# FLORIDA DEPARTMENT OF ENVIRONMENTAL PROTECTION SOLID WASTE MANAGEMENT FACILITY INSPECTION CHECKLIST

Facility Name: FLORIDA CRUSHED STONE WTPF  
 WACS No.: SND/27/40778 COMET Project Number: 87650  
 Inspection Date: 10-18-06 Permit No.: 22787-002-WT Expiration Date: 12-6-05  
 Facility Address: 10311 CEMENT PLANT RD.  
 City: BROOKSVILLE County: HERNANDO Zip: 34601  
 Permittee or Operating Authority: FCS COMPANY  
 Telephone Number (Permittee or Operating Authority): (352) 799-7881  
 Inspection Participants (Include ALL Landfill and Department Employees With Corresponding Titles):  
 Principal Inspector: STEVE MORGAN, SELENA WILLIAMS  
 Other Participants: BILL BUTLER

RE: Response to request for information dated June 15, 2005  
Solid waste and industrial by-product management

On April 5, 2005, Department solid waste staff (Susan Pelz and Lora Ross) and industrial wastewater staff (Cindy Falandysz) conducted an inspection of the above-referenced facility. The facility has recently requested that all activities not regulated by federal programs be authorized through the site's Conditions of Certification issued through the Department's Power Plant Siting office in Tallahassee

Photo ID #IMG\_0147 /11:02 AM – Intake structure for alternate pump, notice oil sheen.

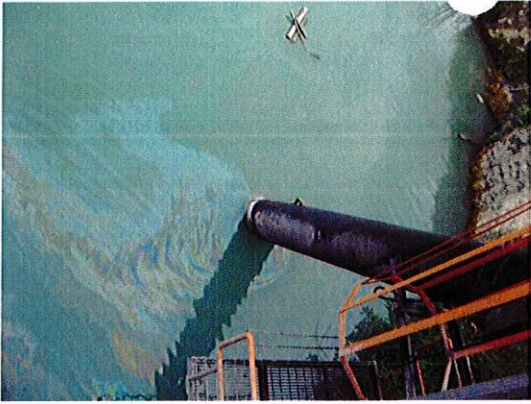
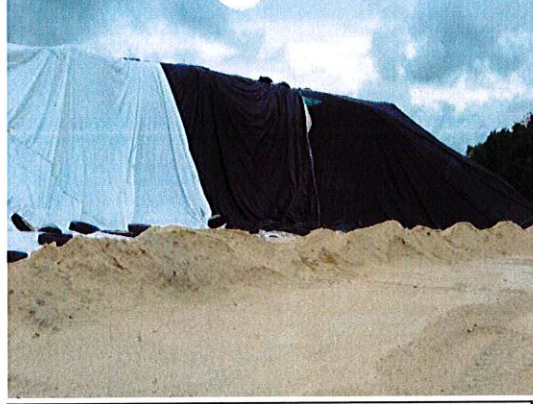
Photo ID #IMG\_0148 /11:04 AM – Source of oil sheen from alternate pump.

-pile 3 (Tercer Gran Ash) ponding water

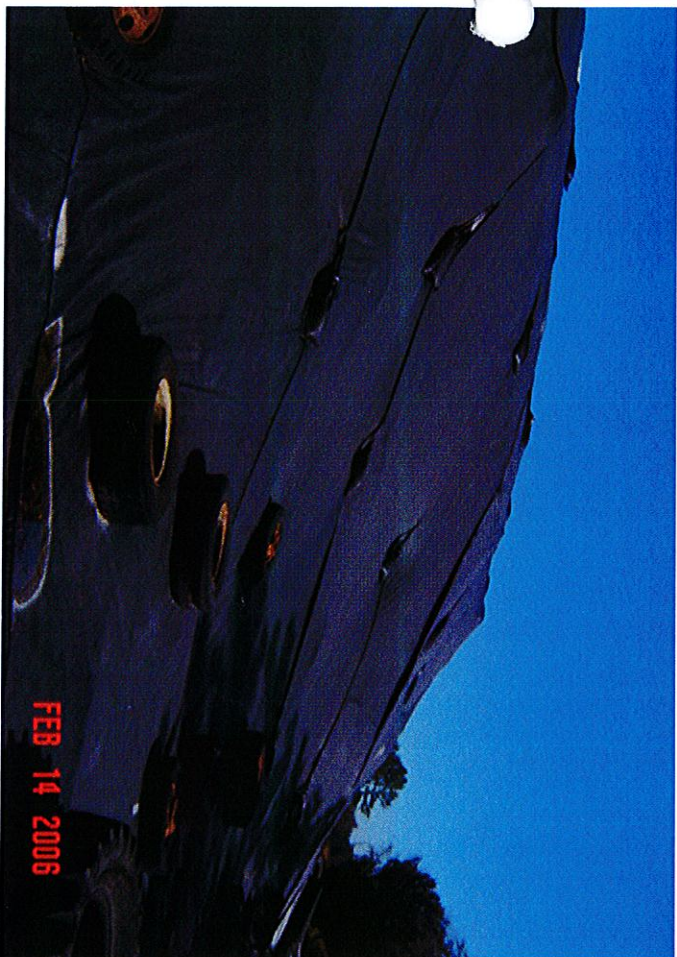
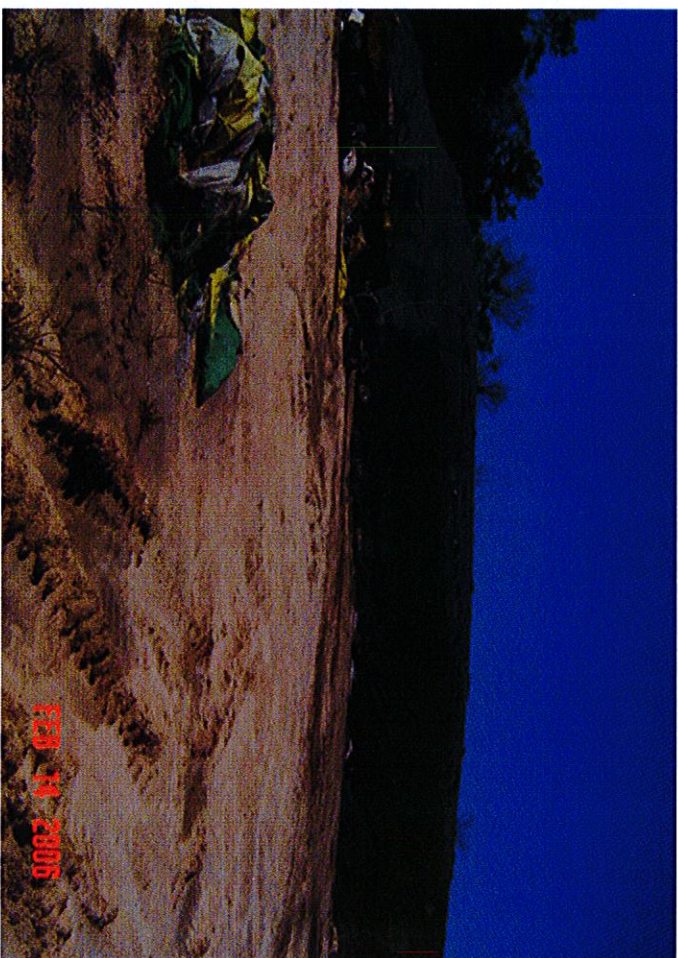
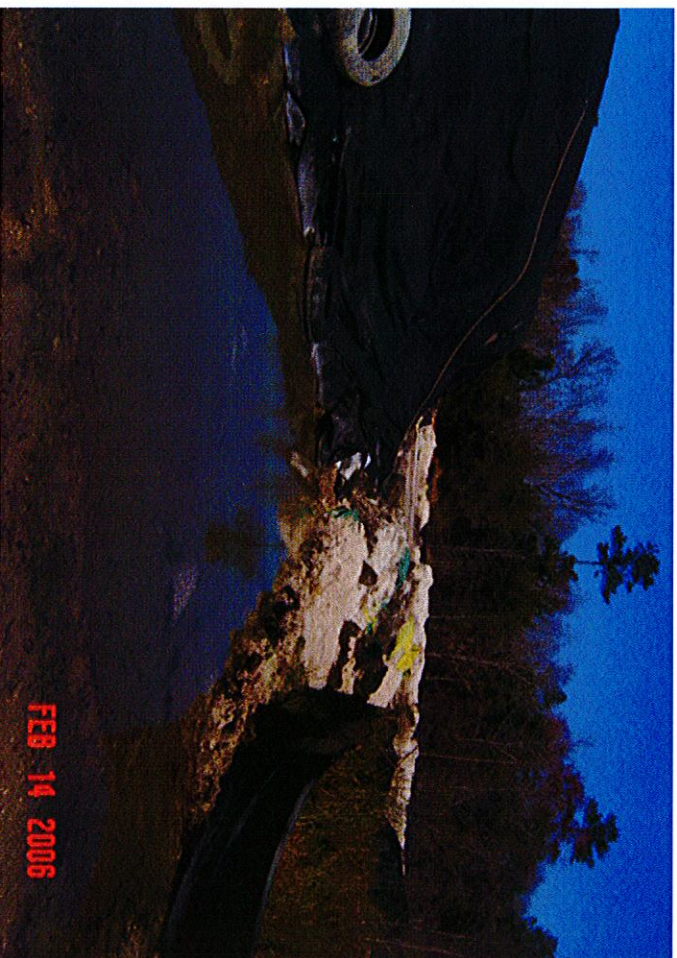
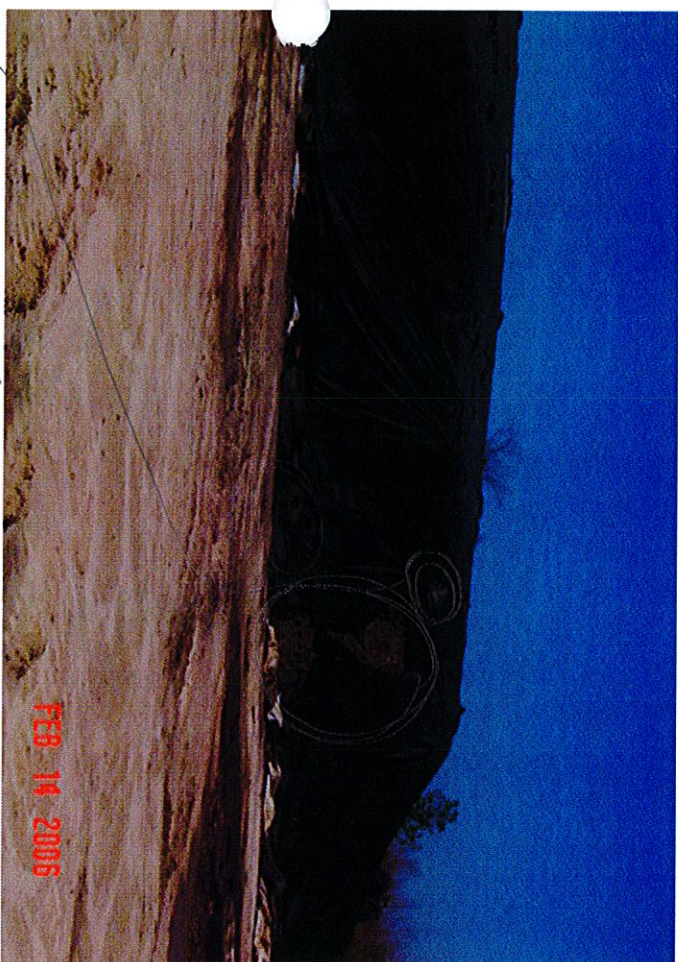
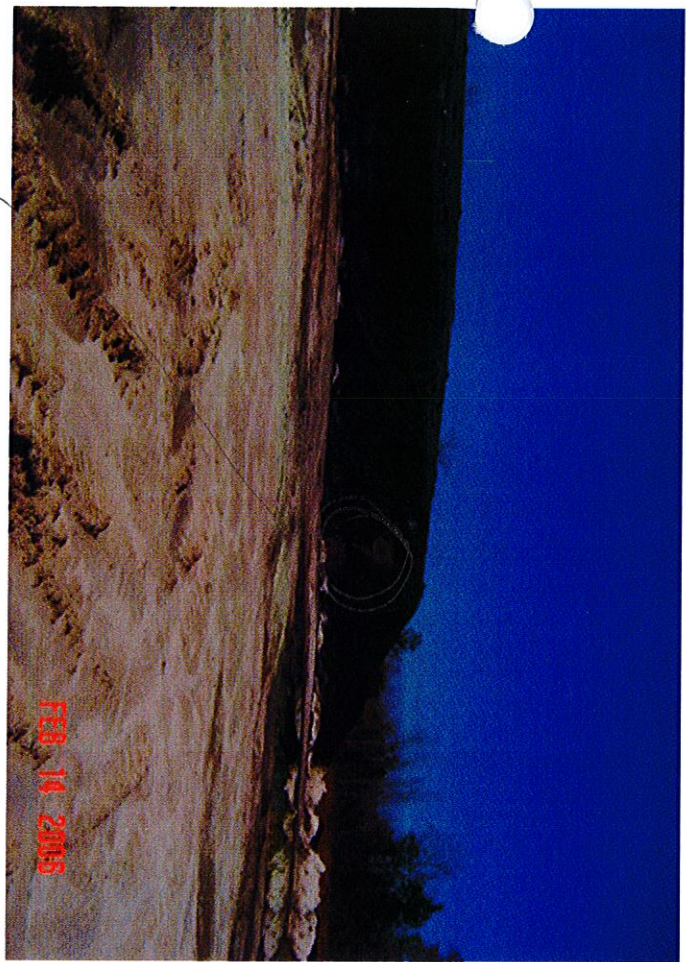
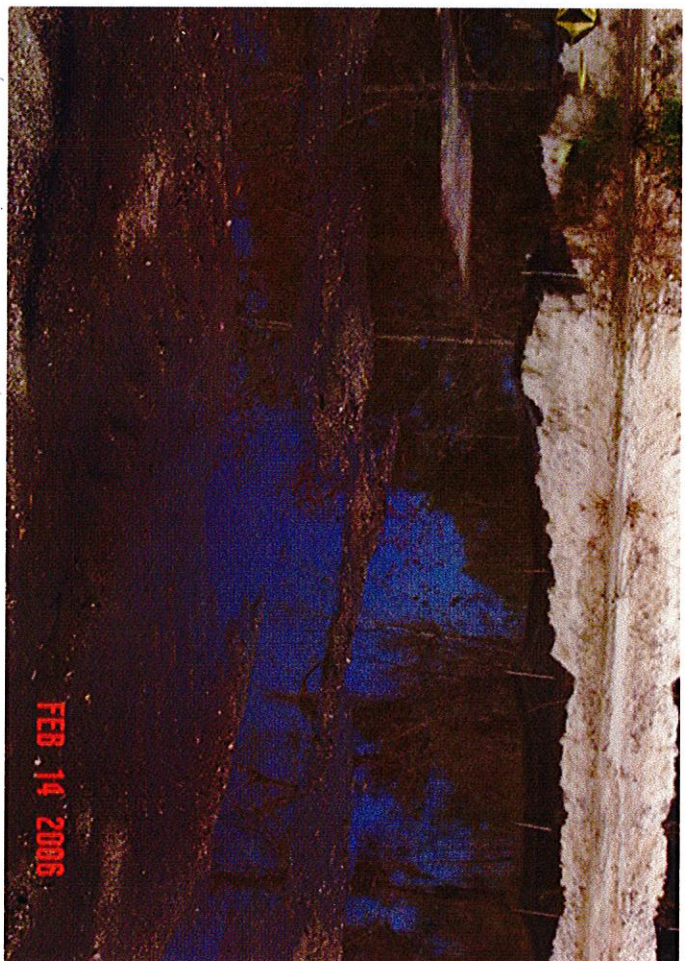
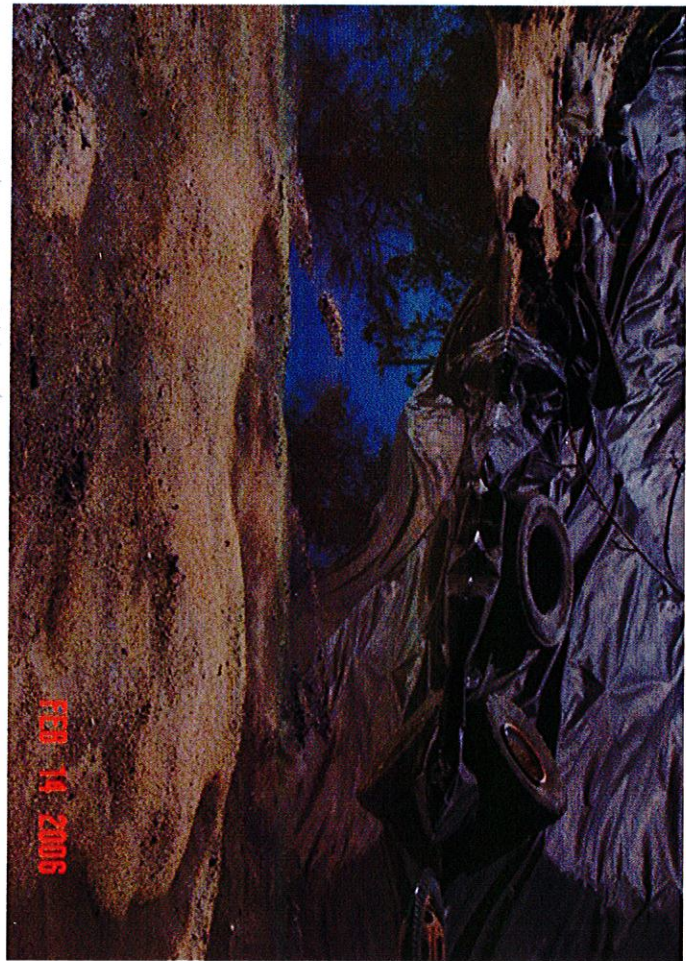
Cribs; part left open on Pile 3

Pile 3 - tarp left open/cracks (same as above)

ponding water by pile 3

water sitting by Pile #3

3. **Gannon Pile #3.** Please clarify where the stormwater runoff from this area is discharged and provide a copy of the permit that authorizes this discharge.

Stormwater runoff from the Gannon Ash Pile #3 is contained within a closed basin. The pile and stormwater containment systems are located within the internally drained sub-basin known as EAST-4 as identified in the PA82-17 Supplemental Environmental Management Plan, Section 3: Site Water Management Plan and Exhibit A: Facility Site Map. Stormwater runoff discharge from the immediate pile and stormwater containment system area is contained within this basin, which historically has received stormwater runoff from the FCS aggregate processing plant and storage areas.

btyhase bags

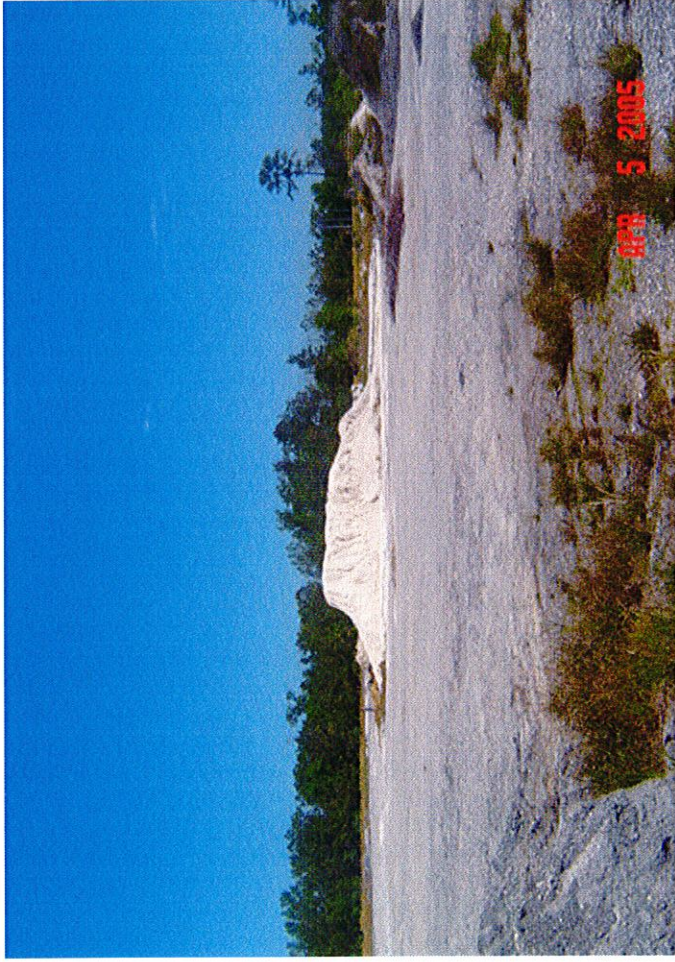
A couple of piles of milled asphalt, one pile of limerock, and a couple of box trailers were observed in this area. A pile of an unknown material was also observed. On closer inspection, it was determined that the material was a pile of baghouse bags. You indicated that the operation that previously leased this part of the property (i.e., the asphalt processing plant) must have left the bags. Stained soils were observed in the vicinity of the bags.

2. **Baghouse bags, submittal from Creative Environmental Solutions dated June 5, 2005.** Since the Chain of Custody does not indicate the matrix that was analyzed, please provide photographs of the samples taken. Please explain the sample designations "SS-1" and "DB-1." At the inspection, it was indicated that the process that generated the bags was likely an asphalt processing facility, and not cement production. Please provide additional leaching results for semi-volatiles parameters. Please explain why the results for sample SS-1 were crossed out on the "Certificate of Analysis Summary 251965." Are these results invalid? If so, why? Please explain why the Chain of Custody does not indicate the matrix analyzed, but the "Certificate of Analysis Summary 251965" indicates that the samples were water. Please provide receipts from the disposal facility for disposal of the baghouse bags. Please provide a signed and sealed copy of the report from Creative Environmental Solutions.

It is clear that neither the soil in the former filter storage area nor the filters themselves are characteristic hazardous wastes based on the TCLP results. No further assessment is warranted. Please call with any questions or comments.

*petroleum contaminated soil*

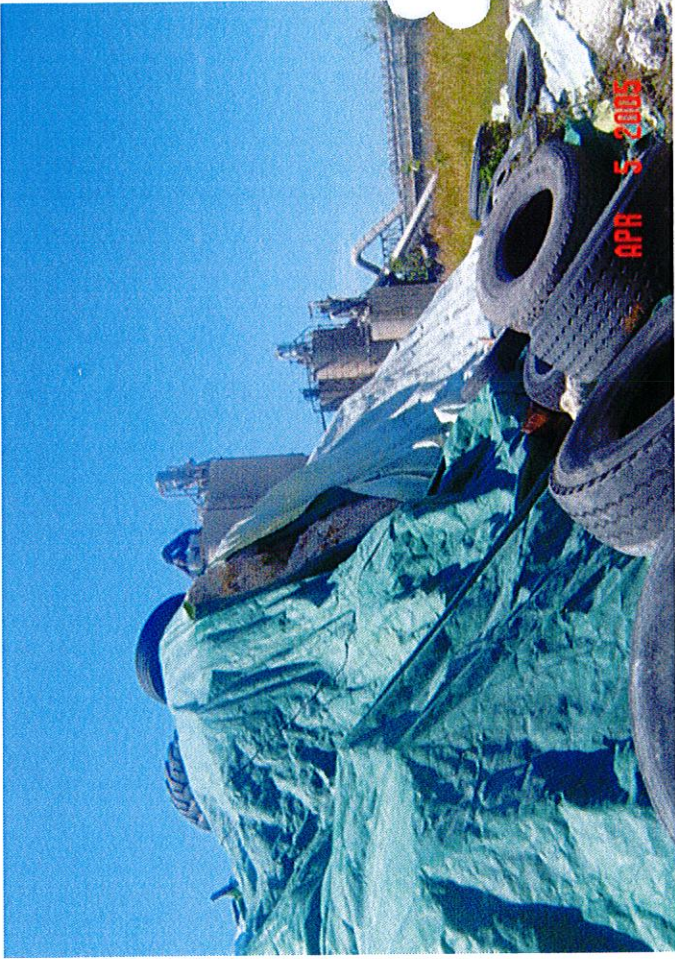
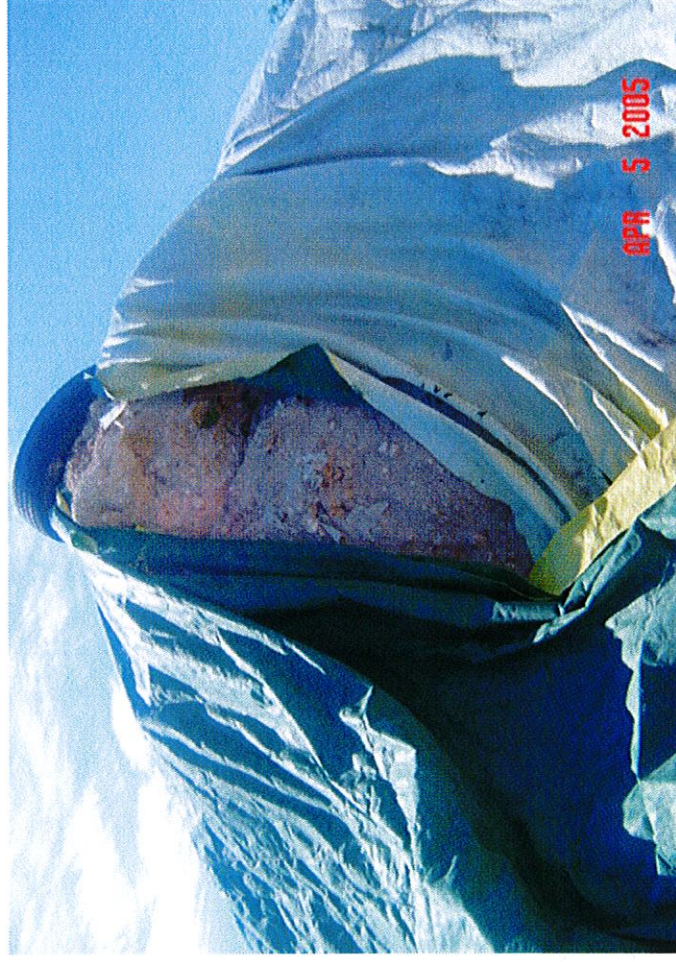
2. Petroleum contaminated soil. Please provide analysis of, and disposal receipts for, the petroleum contaminated soils. Please specify the "licensed disposal facility in south Florida." In the event that all of these soils have not been removed for proper disposal, please provide a schedule for the completion of this activity.

This material was observed stored on the ground north of the cement plant area (at the top part of the cliff) and was only partially covered. As you indicated during the site visit, this material has been stored onsite for greater than 3 years in anticipation of possibly reusing it in the cement manufacturing process. The Department considers the contaminated soil to be solid waste that must be characterized and disposed of properly.

- Please remove the contaminated soil needs to be removed + the area may possibly need to be assessed.

The ditch cleanings and petroleum contaminated soil referenced in your letter are not considered byproducts of planned use at the facility and are, therefore, not included in the inventory provided for your review. The ditch cleanings come from CPL Plant main ditch and consist of limestone fines that are recycled through the raw material feed to the Cement Plant. The petroleum contaminated soil was generated from mitigation clean up activities at the CPL Plant and is currently in process of being transferred and disposed at a licensed disposal facility in south Florida.
